Report to Planning and Environment Committee

Subject: Daniel Boyer (c/o Polocorp Inc.)
1515 Trossacks Avenue
File Number: Z-9632, Ward 05
Public Participation Meeting

Date: September 11, 2023

Figure 3 - Conceptual Site Plan (Received June 2023)

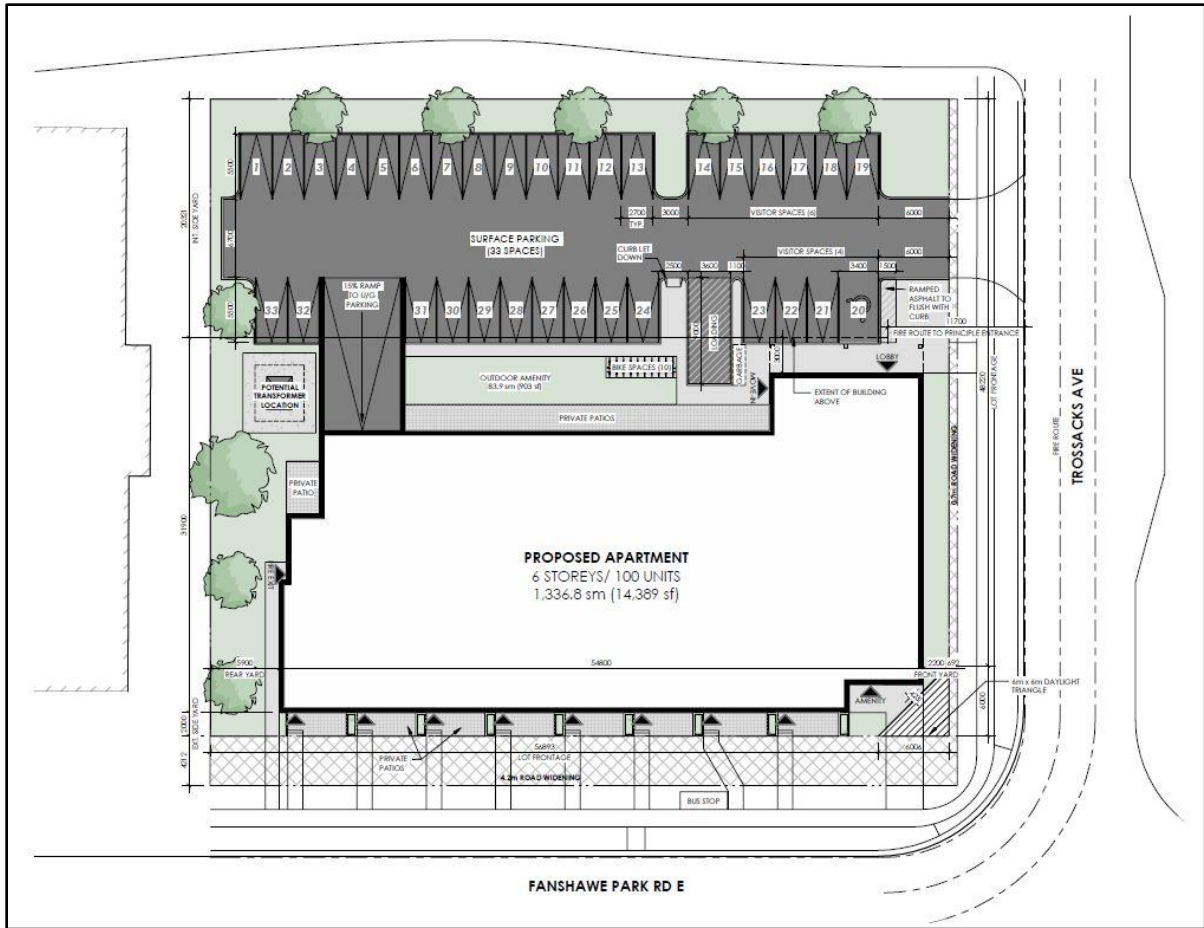
The panel requests that the road widening right of way be clarified. Is it the entire 4.2M wide hatched pattern shown on the site plan? We are assuming it is and the setback along Fanshawe Park Road is 2.0M wide. For example, consider the functionality of a future bus stop which would be much too close to the building frontage. The building should be designed to the future setback.

The panel suggest reviewing the following with the city: Fanshawe Park Road is already a 4-lane road with bike lanes and 2 lanes of traffic each way. If it is revised to a 6-lane road, bike lanes should be moved to the boulevard to have a buffer from the traffic. We suggest the future intent of the road widening should be clarified and the building setback should be determined accordingly.

We suggest that streetscape plan along both frontages should be developed and reviewed with the city to make sure lines of trees can be added to either the public or the private side.

The panel agrees with the City Staff's comments regarding minimizing the amount of surface parking and accommodating the parking underground to provide adequate amenity spaces, to assist with storm water runoff and opportunity for landscape planting.

Road widenings are represented by a hatched pattern on the Site Plan and based on the requirements indicated by City Staff in the Record of Site Plan Consultation, dated March 1, 2023. Staff indicated that the intent of the widening is to achieve the required right-of-way (22.5 m on Fanshawe Park Road and 10.75 m on Trossacks Avenue) from the centerline.

It is our understanding that there are no plans for further road improvements on Fanshawe Park Road or Trossacks Avenue in the foreseeable future. As such, the bus stop will remain functional in its current location and will be accommodated in the public right-of-way at the time of a future road widening. The proposed setbacks have no negative impact on the bus stop.

It is also our understanding that road improvements have recently been completed and that there are no plans for further expansion to Fanshawe Park Road. Further, we note that Staff have indicated desire for pedestrian connections on Fanshawe Park Road. Pedestrian Connections are typically not desirable on a 6-lane, high speed road. As such, based on our understanding of City's intent for Fanshawe Park Road, the practical setback of the proposed building from the abutting road will be over 6.2 meters, which is appropriate given the context and the surrounding developments.

Polocorp Inc. met with Staff to discuss the Site Plan Pre-Consultation comments on March 2, 2023. Staff indicated at the meeting that tree planting can be accommodated within the public right-of-way.

The Applicant is proposing to address the above comments by enclosing the parking ramp to align with the surface parking spaces and utilizing the rooftop area as additional outdoor amenity space. The Applicant will provide conceptual programming of the outdoor amenity areas in response to post-circulation comments, or at Site Plan stage, as required.

The Applicant is proposing to address the above comment by enclosing the ramp to align with the outdoor parking spaces. The rooftop area resulting from the above will be utilized as an additional outdoor amenity area. By enclosing the ramp, it will be more visually integrated within the massing of the building. The Applicant will provide conceptual programming of the outdoor amenity areas for Staff's reference as a part of a response package to detailed post-circulation comments, or at Site Plan stage as required.
